## **DESIGN REVIEW - FACADE RETENTION PROPOSED DEVELOPMENT - DA2019/359 23 CHURCH AVENUE & 16-18 JOHN STREET, MASCOT**

We have been requested by the applicant to review the proposed retention of the existing masonry facade to the Church Avenue frontage. We have reviewed the applicable drawings as well as the following documents:

**Figure 1**

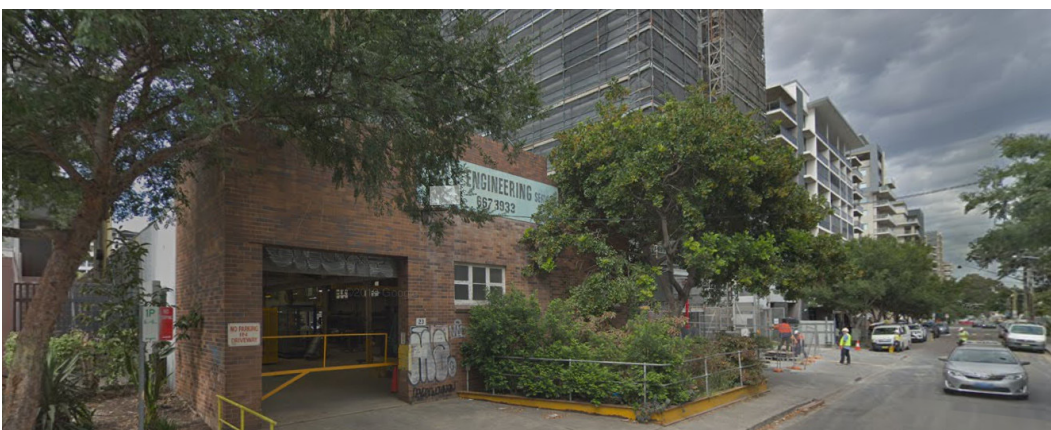
Image of the existing facade proposed to be retained. Note the line of mature trees that line the avenue
